FROM: Matt Murawski, PE
TO: Hinesburg DRB
DATE: October 4, 2022

SUBJECT: Hinesburg Center II – Additional Hydraulic Information

This memorandum provides additional hydraulic information for the Hinesburg Center II application, as requested in the September 30, 2022 staff report. It is intended to augment in-person discussion at tonight's (10/4/22) DRB hearing.

OVERALL SITE PLAN

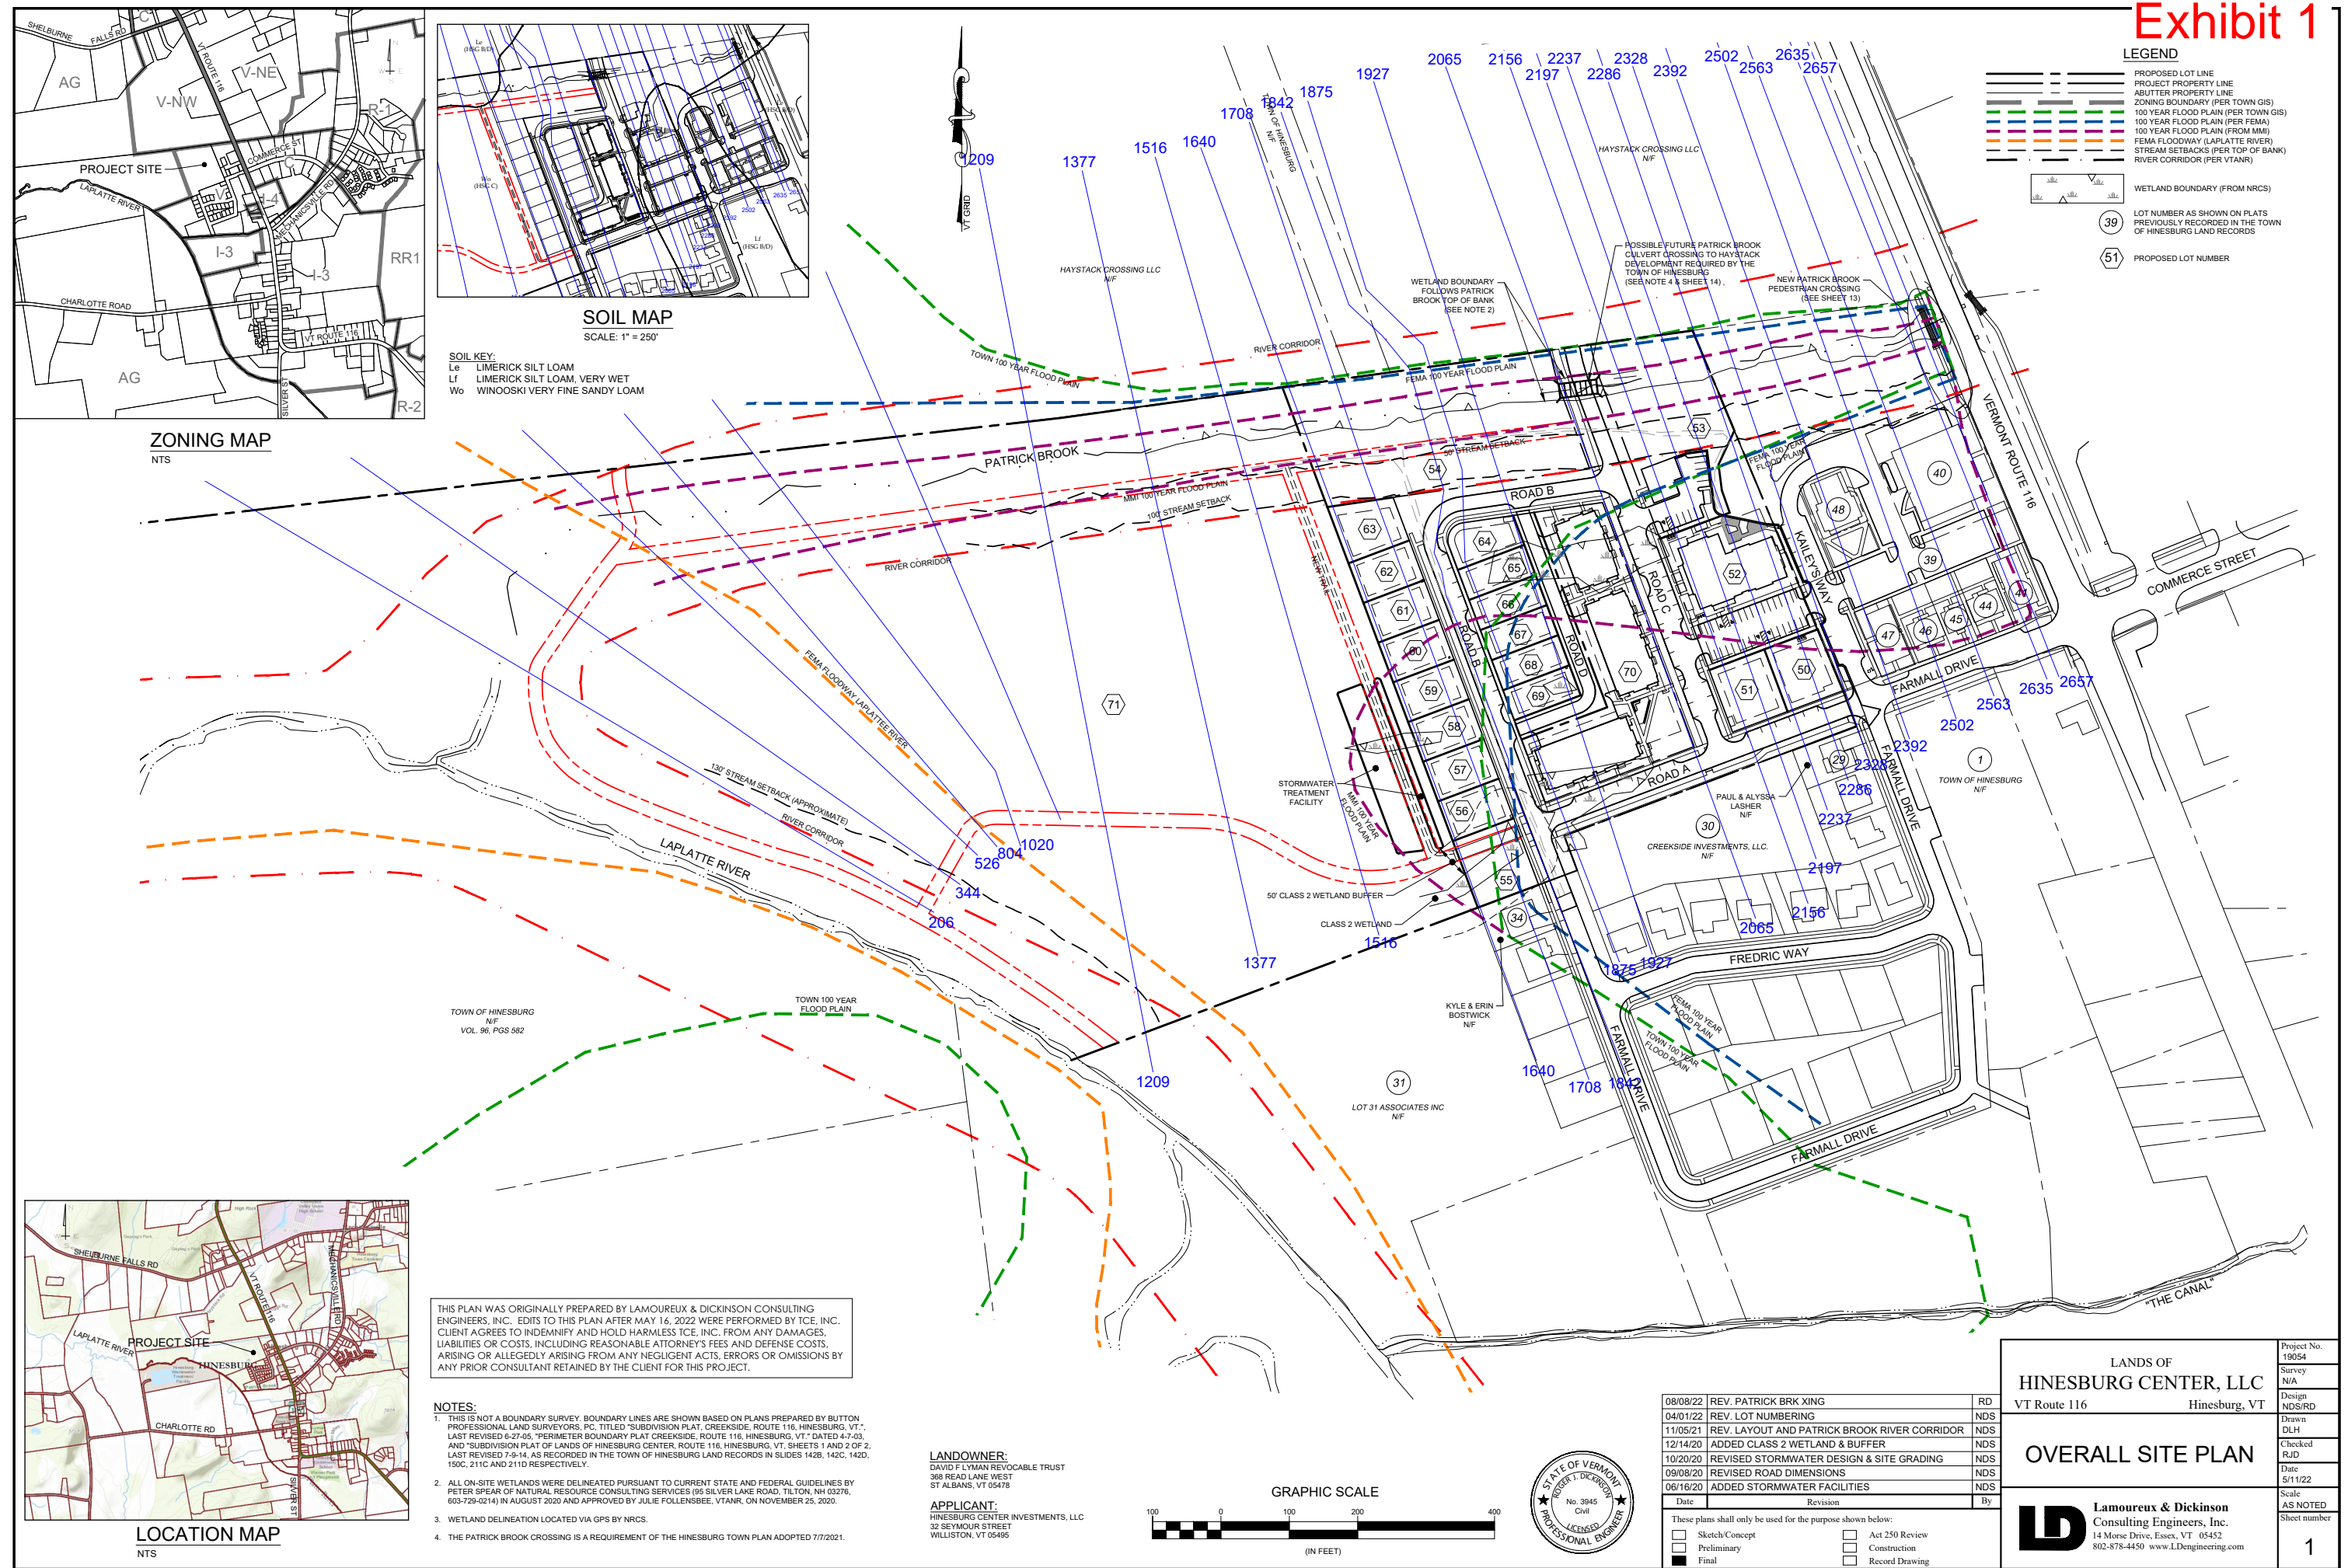
1. **Need for a Plan.** Exhibit 1 shows the cross sections on the project Site Plan.
2. **Cross Section Scale and Vertical Exaggeration.** Exhibit 2 shows a “zoomed in” cross section 1875 which is the location of the largest difference in water surface elevation between Existing and Proposed Conditions. At most cross sections, Existing and Proposed appear as a single line because the difference in elevations is so small, and thus the other zoomed in sections are not presented.

Exhibit 3

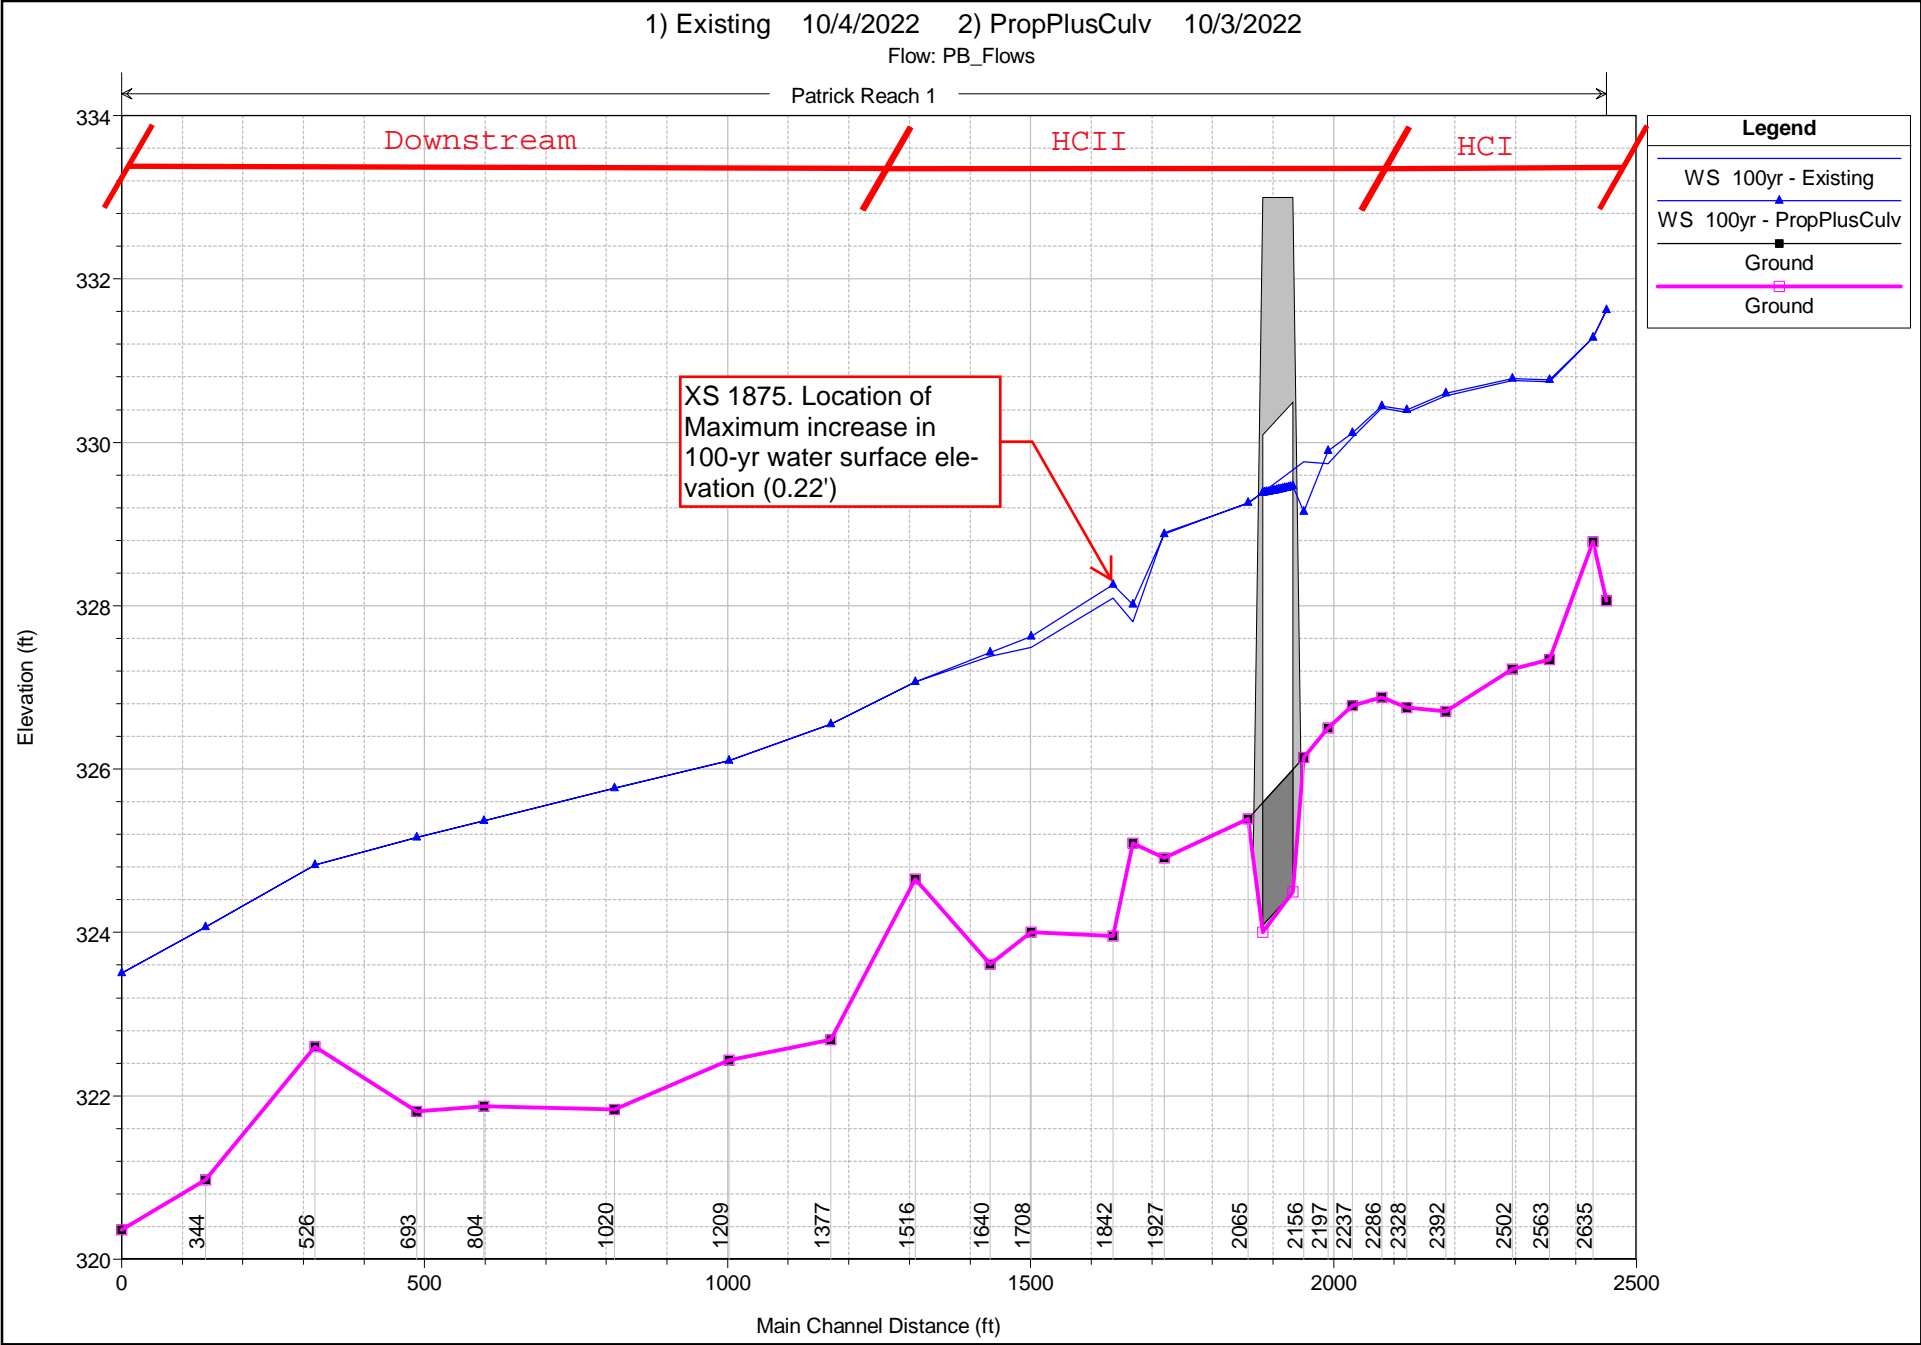
3. **Existing Conditions Modeling.** Existing Conditions – reflecting topographic conditions on the ground today – have been modeled. Exhibit 3 shows the Profile down the river of both Existing and Proposed Conditions, and Exhibit 4 is an annotated table presenting the same results.
